# Technical Service Information

## CHRYSLER 46RE DIAGNOSTIC TROUBLE CODE P1740

Figure 1

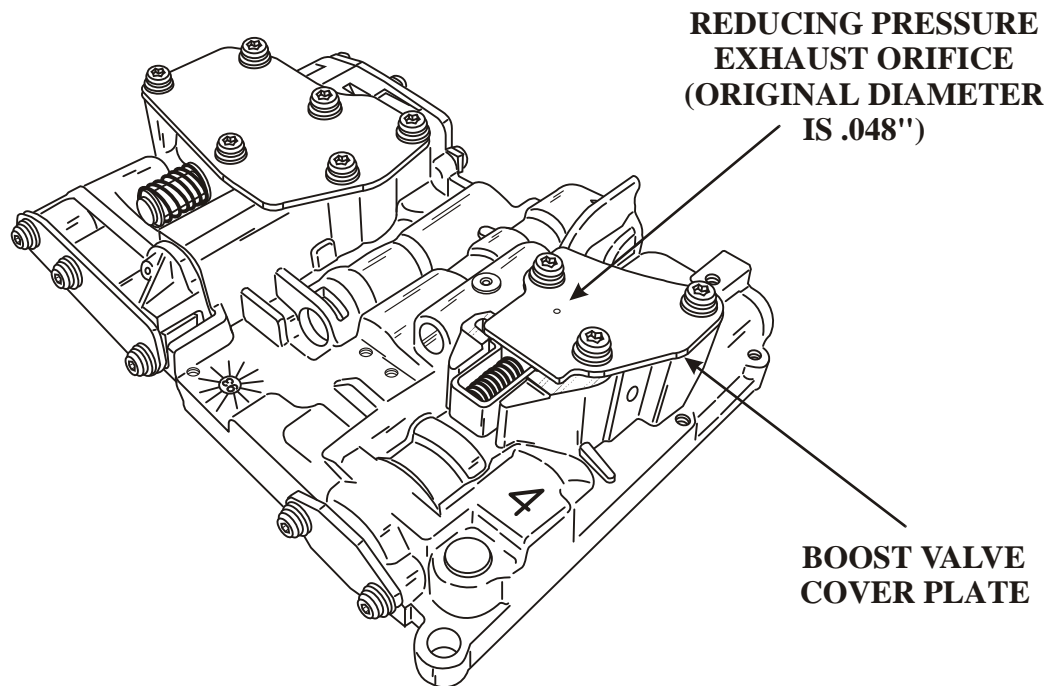
**CAUSE:** The cause may be, a Reducing Pressure Exhaust orifice that is too small, which delays the pressure increase needed when the Torque Converter Clutch is applied. Refer to Figures 2 and 3 for a partial hydraulic schematics explaining the Boost Valves function.

**REMOVE THE BOOST VALVE COVER PLATE AND  
ENLARGE THE REDUCING PRESSURE EXHAUST  
ORIFICE TO .069"**

**CORRECTION:** Refer to Figure 1 to locate the Reducing Pressure Exhaust Orifice, which is in the Boost Valve Cover Plate. Remove the plate and enlarge the orifice shown to .069."Chrysler also provides a new Boost Valve Cover Plate which will already have the orifice enlarged.

Figure 2

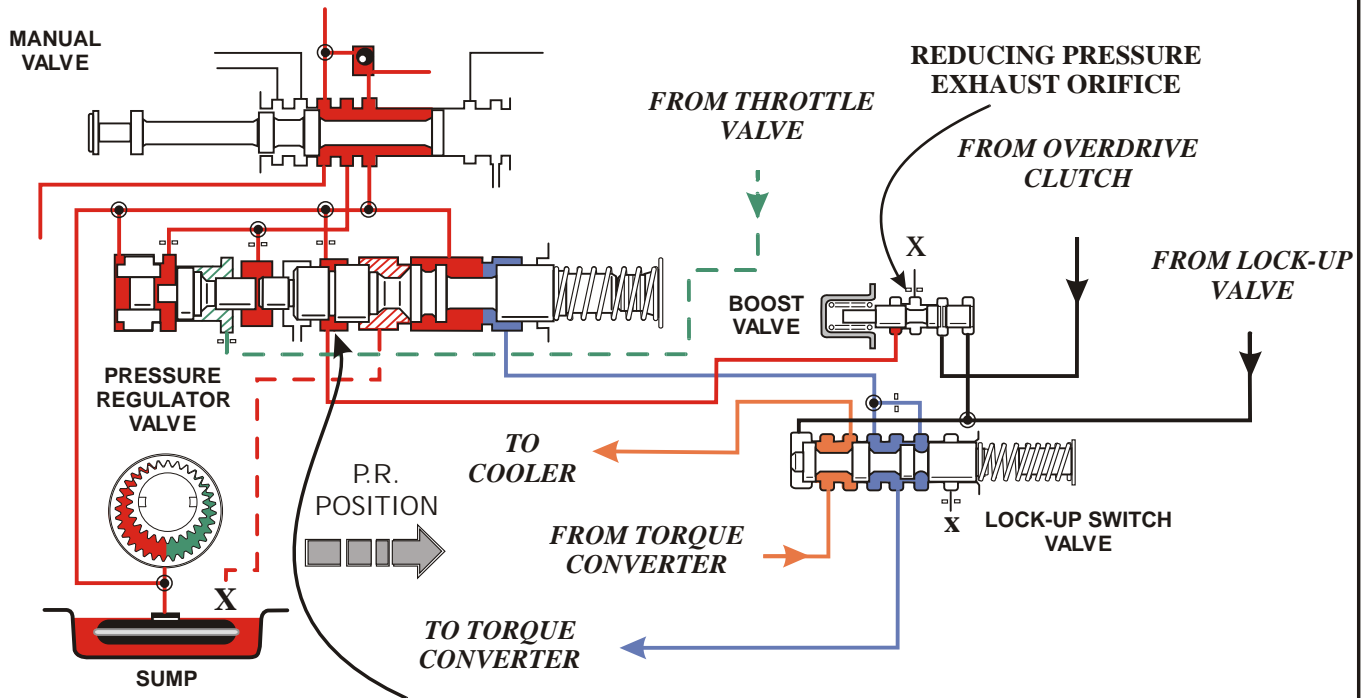
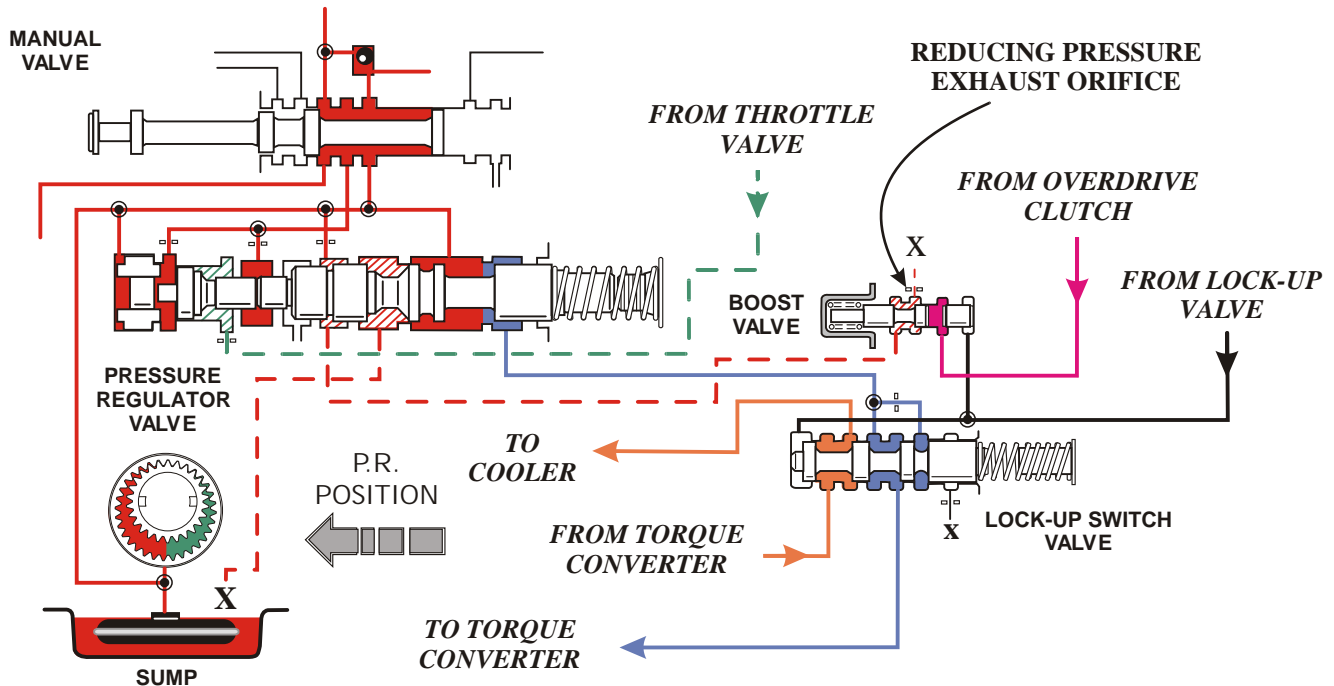
**Summary:** The Boost Valve is stroked via Overdrive Clutch pressure or Lock-up Signal Pressure from the Lock-up Valve, while in 3rd or 4th gear. This drains the Reducing Pressure from the 3rd land of the Pressure Regulator Valve. This allows the Pressure Regulator Valve to move to the left, increasing Main Line Pressure.

## PARTIAL HYDRAULIC SCHEMATIC OF PRESSURE REGULATOR VALVE "DRIVE" POSITION 4th GEAR WITH TCC "ON"

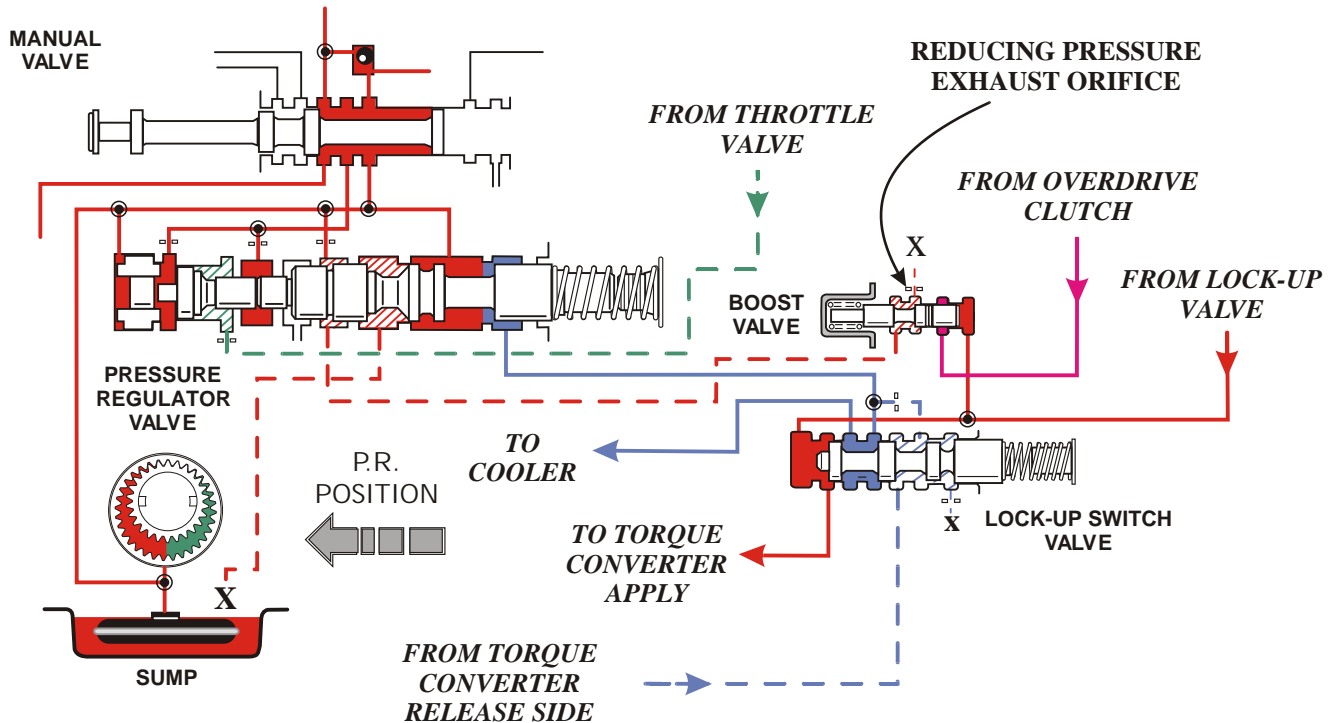
**NOTE:** Increasing the diameter of the Reducing Pressure Exhaust orifice, will allow the Pressure Regulator Valve to stroke to the left at a faster rate which will allow Line Pressure to increase quicker for Torque Converter Clutch application and for the 4th clutch application.
